Oasis Fashion Ltd (Unit 2)

Kashem Complex, Gacha Road, Gazipur
(23.9366637, 90.3723368.24)

15th April 2014

Observations

Ground Floor Plan

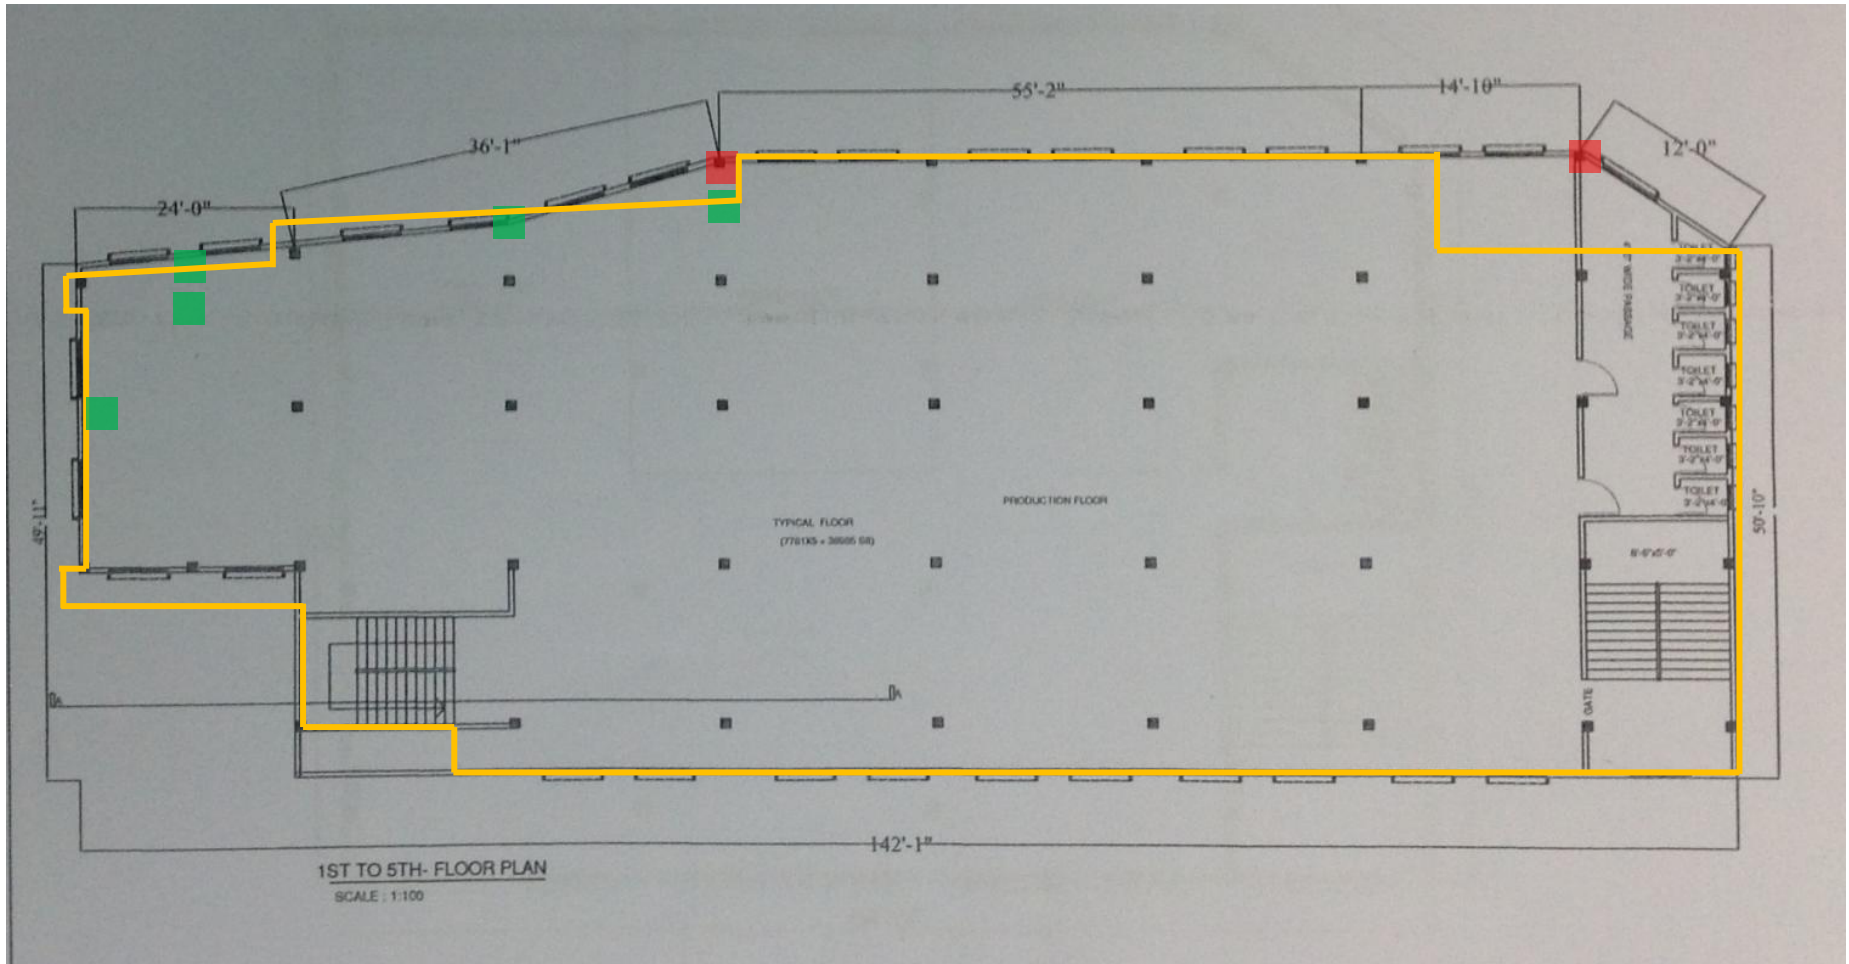
Stress Levels in Columns

Cursory calculations indicate that the working stress of the columns at Ground Floor levels are at a high level. Detailed Engineering Assessment required.

Construction of the main building began in 2006, with construction up to 6th Floor completed by 2012. A lightweight steel roof structure on RC columns, which covers approximately 50% of the floor area, was erected at Roof level in 2012, in lieu of a LGED-approved 7th storey. Brick aggregate was observed in the Ground Floor columns, in accordance with the As-built structural drawings. There is a discrepancy between the drawings and the constructed building in relation to the Ground Floor column reinforcement quantities. Grade 72 High Strength steel is called up in the structural drawings. No exposed reinforcement steel was visible for comparison.

- Building Engineer to review design, loads and column stresses in structure. A Detailed Engineering Assessment of Factory to be commenced – see attached scope.
- Verify insitu concrete stresses by taking 100mm diameter cores from 4 columns at ground floor level.
- Verify number and diameter of reinforcement bars in ground floor columns.

Typical Floor Plan

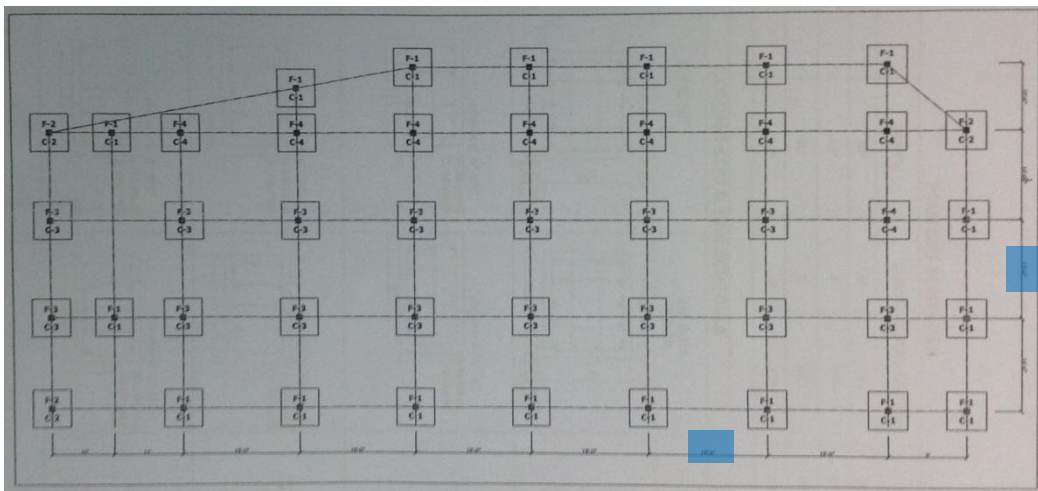
A set of As-built Structural Drawings, 2013, by Rupali Consultants, was made available for review on the day of the survey. A LGED-approved Building Permit Drawing was also made available for review. There are a number of inconsistencies between the drawings and the constructed building. A non-exhaustive list of issues include:

- Inconsistencies in construction type – the structural drawings appear to indicate simple flat slab construction, whereas flat slab with drops is observed at Ground, 1st and 2nd Floor levels (with some beam and slab observed to the South of the building), and beam and slab is observed at 3rd, 4th and 5th Floor levels;
- Inconsistencies in column / beam layout, particularly to the south of the building;
- Inconsistencies in building footprint, particularly to the south of the main building, and to Shed no. 2;
- Inconsistencies in rebar quantities;
- Slab thickness is called up as 6” in the drawings, whereas a minimum of 7” is observed;
- Banglalink Telecom tower above South stair is not called up in the drawings.

Additional Columns

Misplaced / Non-existent Columns

Apparent Building Footprint

Building Engineer to review and provide clarification.

- Engage a Building Engineer to survey the structure and prepare a full set of “as-constructed” drawings.

Column Layout

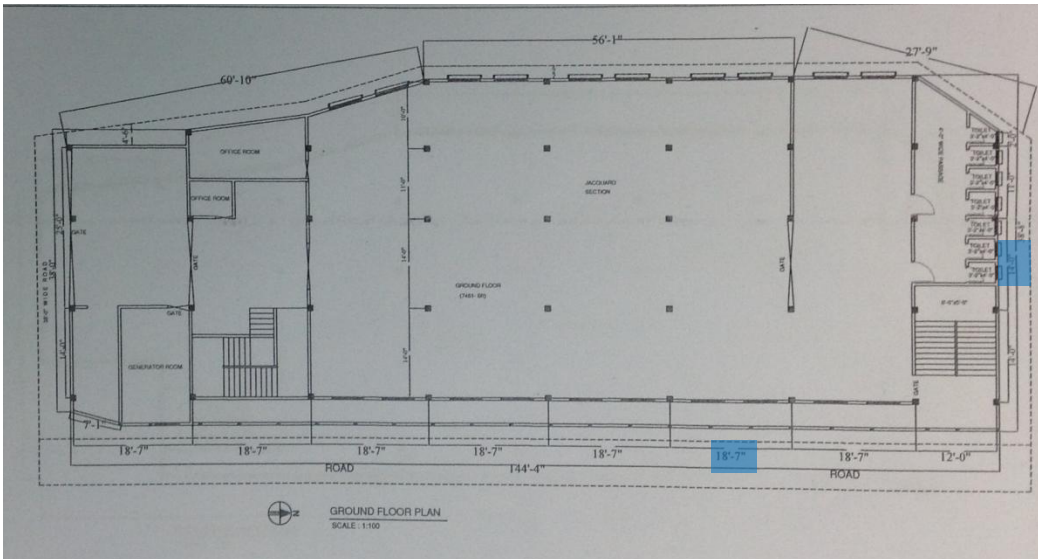
Inconsistencies in Grid Dimensions:
The Column Layout Plan call up a maximum grid size of 18.7" x 14.0" for an internal bay, whereas the Ground Floor Plan calls up 18.0" x 15.6" for the same bay.

Inconsistencies in Rebar schedule

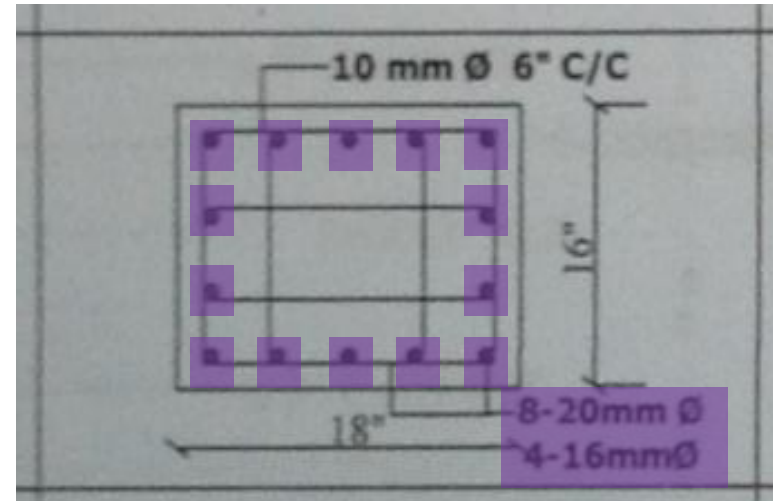
Inconsistencies in Rebar Quantities:
The reinforcement quantity written in the schedule (8 + 4 = 12 bars) is different from that shown schematically (14 bars).

Lightweight steel structures do not appear to be engineered

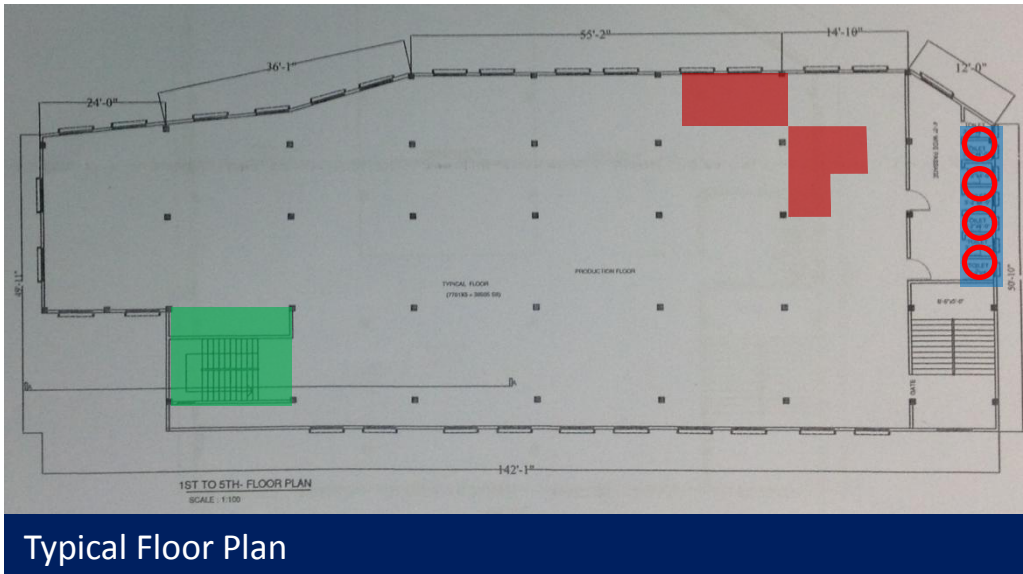
The factory compound comprises a number of lightweight structures, namely the Dining area at 6th Floor level, and the two large sheds at ground floor level. These structures, which consist of lightweight steel-trussed roofs on RC columns, do not appear to be engineered. Building Engineer to review the design of these structures, with special emphasis on connections and bracing, and to implement any upgrade works as required.

- Engage a Building Engineer to check the capacity of the lightweight 'warehouse' structures / connection details and 6th floor structure/connection details and make any necessary alterations.
